**Piper Aircraft, Inc.**  
 2926 Piper Drive  
 Vero Beach, FL, U.S.A. 32960

# SERVICE NO. 1375B BULLETIN

**SUBJECT:** PERIODIC REPLACEMENT OF MAIN LANDING GEAR ATTACHMENT HARDWARE

**REASON FOR REVISION:** SB 1375B corrects fastener call outs, model names, revises instructions, and updates formatting.

**Figure 1**  
Main Landing Gear – Mounting Hardware

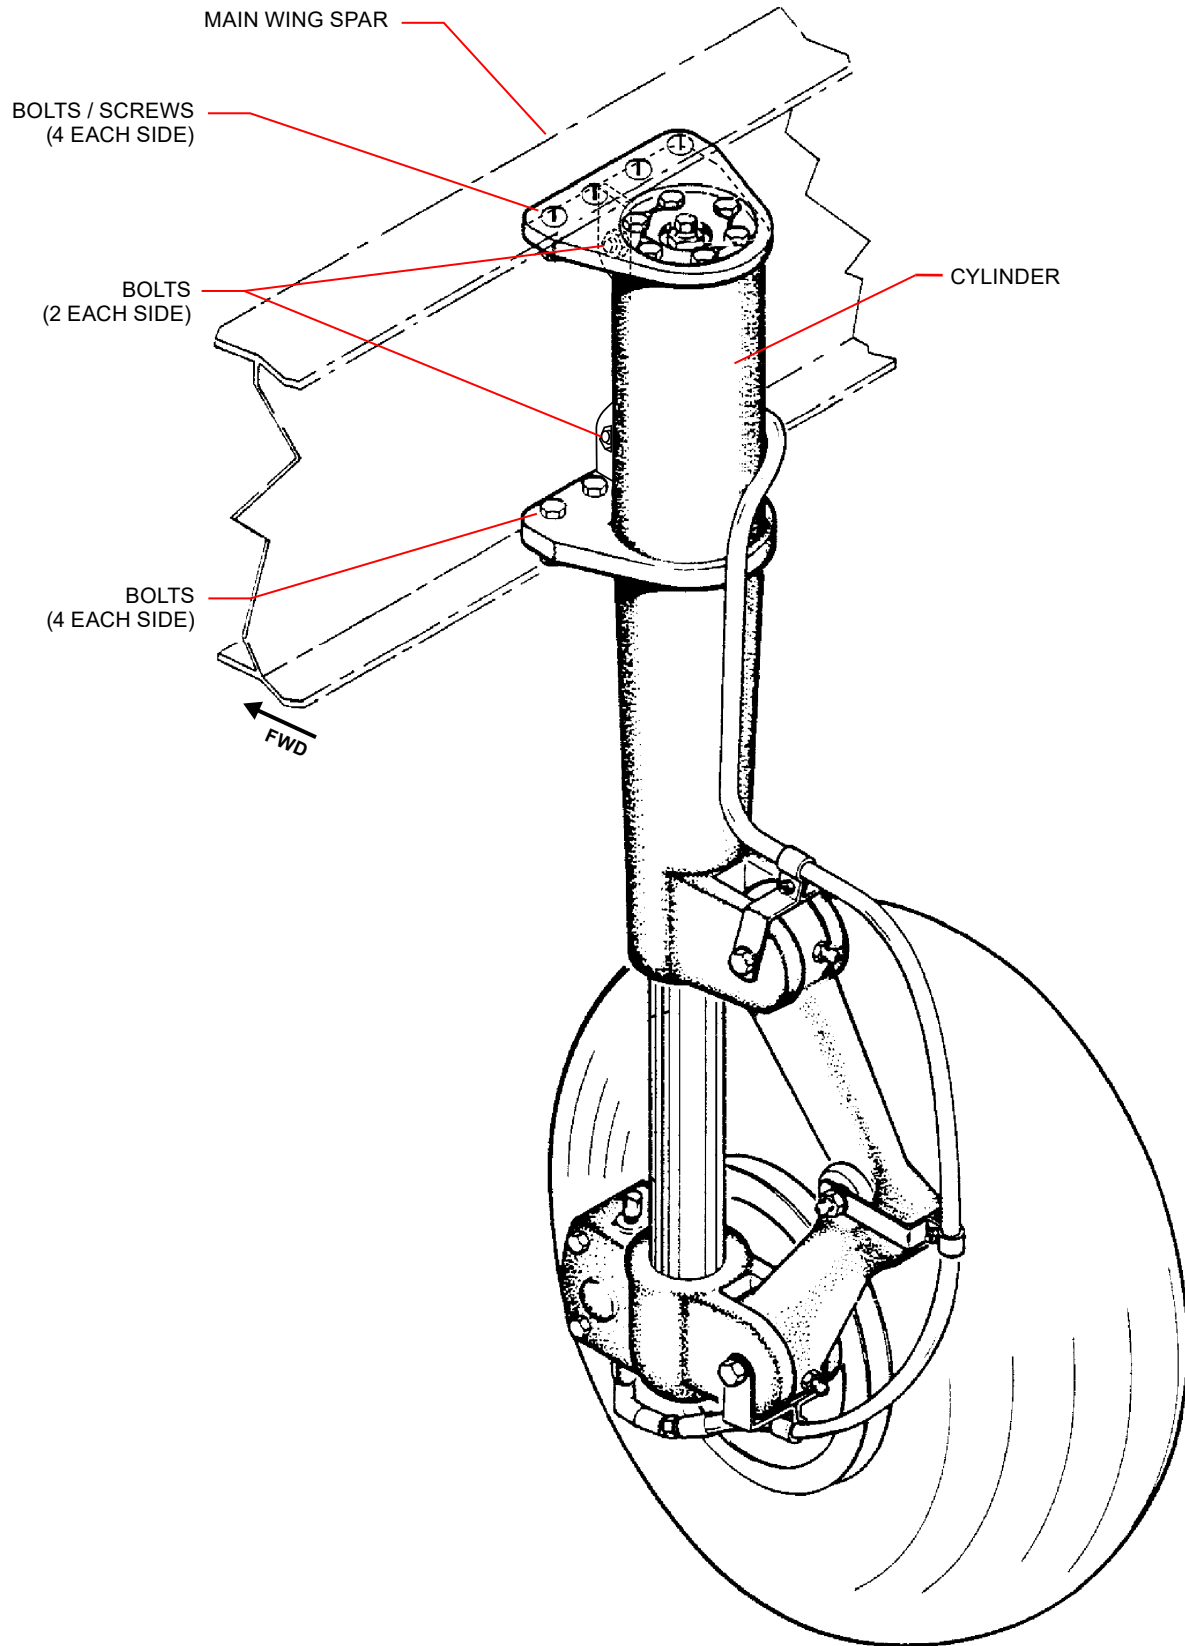
The main landing gear (MLG) are attached to the aircraft with threaded fasteners that pass through mounting flanges on the strut cylinder and the upper and lower flanges of the main wing spar, as depicted in the illustration below. On some of the affected aircraft, additional threaded fasteners pass through the web of the main wing spar.

1. Place the aircraft on jacks.
2. Remove the fairing from around the strut cylinder housing and the access plate located on the bottom of the wing and to the rear of the housing by removing attaching screws.
3. Remove the MLG and discard all of the threaded fastener stack ups (which includes screws, bolts, nuts, and washers) that attach the MLG to the main wing spar. (See Figure 1.)

Service Bulletin (SB) 1375B supersedes SB 1375A for bolt hole inspections. However, if any of the four factory original screws in the upper flange were replaced with oversize fasteners as part of compliance with SB1375A, contact Piper for disposition.

**WARNING:** SB 1375A SPECIFIED INCORRECT REPLACEMENT SCREWS FOR THE UPPER FLANGE. ACCORDINGLY, IF ANY OF THE FOUR FACTORY ORIGINAL SCREWS IN THE UPPER FLANGE WERE REPLACED WITH OVERSIZE FASTENERS AS PART OF COMPLIANCE WITH SB1375A, THE AIRCRAFT MAY NO LONGER BE AIRWORTHY, CONTACT PIPER FOR DISPOSITION.
